UNITED STATES PATENT AND TRADEMARK OFFICE

10/784,628

Office Action Summary	Application No. 10/784,628	Applicant(s) ERRICO ET AL.	
	Examiner CHRISTINA NEGRELLI	Art Unit 3733

DETAILED ACTION

Fig. 4

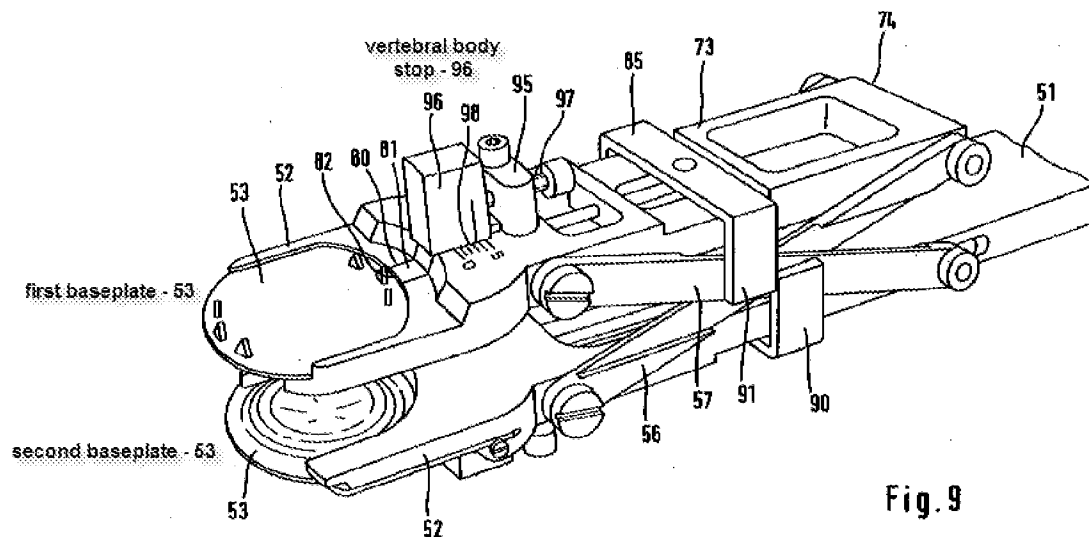
confronting surfaces (see Fig.4) angled with respect to one another. The apparatus further comprises at least one shaft (Fig.4, ref. 20) having a longitudinal axis and a shaft distal end having ***integrally connected*** a top and bottom sets of first, second and third forward surfaces (Fig.4, refs.4, 17) angled with respect to one another ***separated by a wedge portion having an angled top surface, a forward surface and an angled bottom surface, the top and bottom sets of first*** (see Figure 3), ***second, and third forward surfaces configured to*** engage the confronting surfaces (Fig.4) of the baseplates for axial rotationally aligning the baseplates with respect to the longitudinal axis of the shaft in at least two of a plurality of possible axial rotationally aligned positions (para.0040). When the apparatus is engaged to the orthopedic device during manipulation at least two of the top set of first, second and third forward surfaces of the apparatus engage at least two of the first, second and third confronting surfaces of the first baseplate and at least two of the bottom set of first, second and third forward surfaces of the apparatus engage at least two of the first, second and third confronting surfaces of the second baseplate (see Fig.9).

Keller further discloses wherein the forward surfaces (Fig.4, refs. 4, 17) are angled with respect to one another at an orientation angle that facilitates engagement of the apparatus with the device in a plurality of rotated positions with respect to the device such that possible engagement orientations approaches include at least an anterior insertion approach and at least one anterior-lateral insertion approach (para.0040).

Keller further discloses wherein the forward surfaces (Fig.4, refs. 4, 17) are adapted for engagement with the device such that either an anterior-laterally facing

Keller further discloses wherein the anteriorly facing forward surface (see Fig.4, ref.17) is spaced from the anteriorly facing confronting surface when two anterior-laterally facing surfaces are engaged with two anterior-laterally facing forward surfaces (see Fig.4, ref.4). This spacing is caused by a stop (see Fig.4, ref. 15) that controls the spacing of the device and the apparatus (para.0030). Keller also discloses wherein engagement of at least two of the forward surfaces (see Fig.4, ref. 4) with at least two of the confronting surfaces significantly limits movement and rotation of the at least one of the baseplates (ref. 53) relative to the apparatus (see Fig.9).

Keller further discloses a vertebral body stop (Fig.4, ref.96), wherein the stop prevents over-insertion of the device into an intervertebral space (para.0040).

Fig. 9

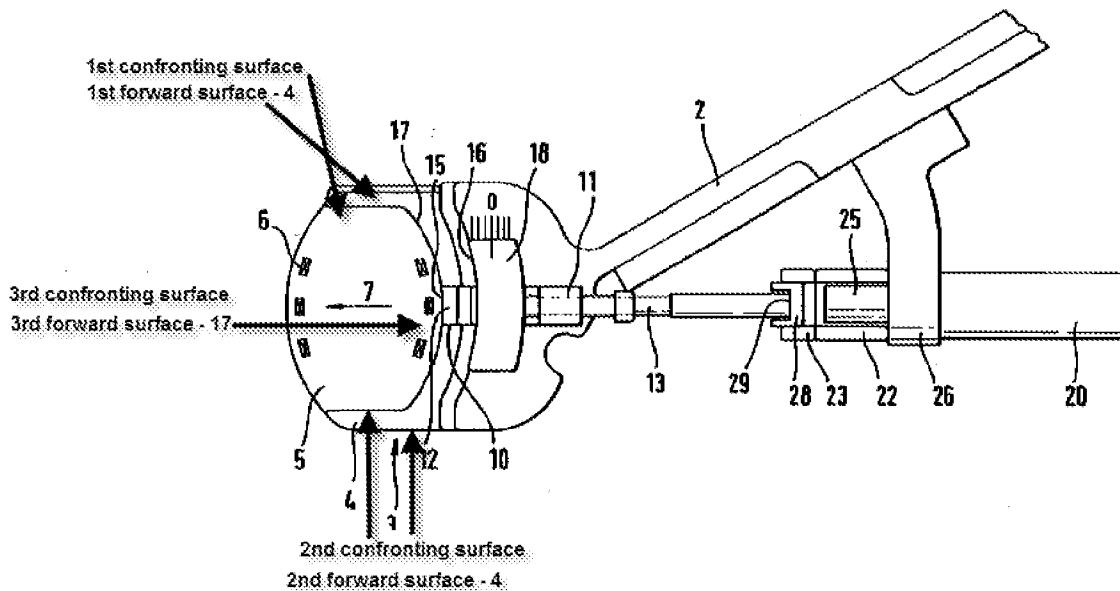
Keller discloses an apparatus having first and second baseplates (see Fig.9, ref.53), the first baseplate having a first vertebral body contacting surface and first, second and third confronting surfaces angled with respect to one another, the second baseplate having a second vertebral body contacting surface and first, second and third

Fig. 3

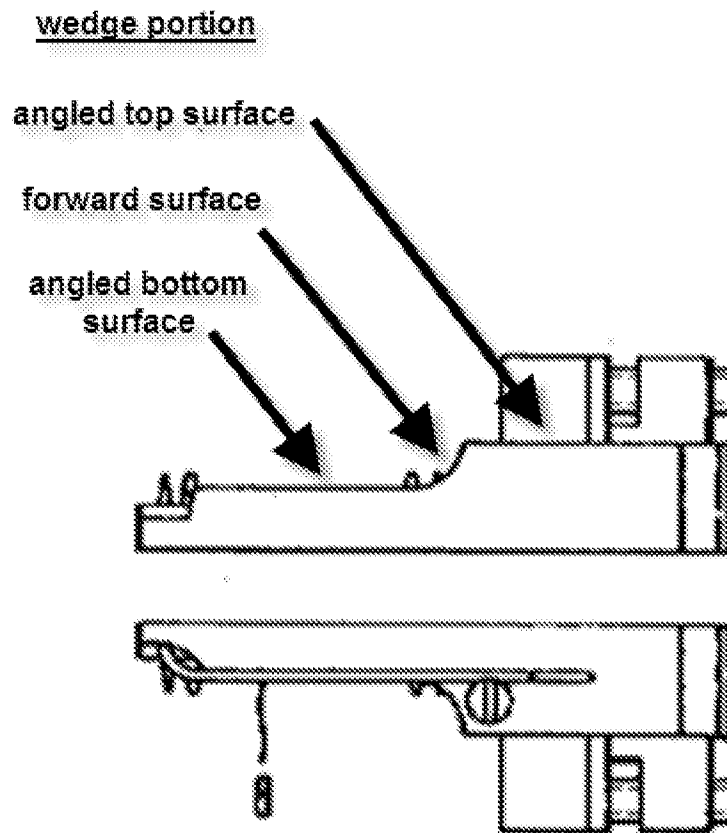
Keller discloses second and third forward surfaces angled with respect to one another (as seen in Figure 4 annotated above) **separated by a wedge portion having an angled top surface, a forward surface and an angled bottom surface** (see Figure 3 annotated below), **the top and bottom sets of first, second, and third forward surfaces configured to** engage the confronting surfaces of the baseplates. The rejection of independent claim 1 and dependent claims 4-7 and 9-11 still stand supported by the Keller prior art reference.
